REMARKS

Reconsideration of the above-identified Application is respectfully requested. Claims 1-24 are in the case. No amendments have been made to the Claims. The Specification has been amended. The Drawings have been amended.

FIG. 1
(PRIOR ART)

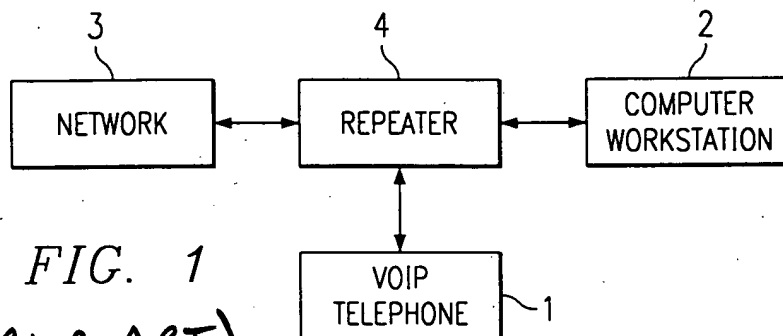
Regarding the objection to the drawings, Figure 1 has been amended to include the legend --(Prior Art)--, as kindly suggested by the Examiner. It is therefore respectfully submitted that the objection has been overcome. Wherefore reconsideration and withdrawal of this objection are respectfully requested.

In Figure 1, add the legend --(Prior Art)--, as shown in the accompanying replacement Sheet 1 of the Drawings.
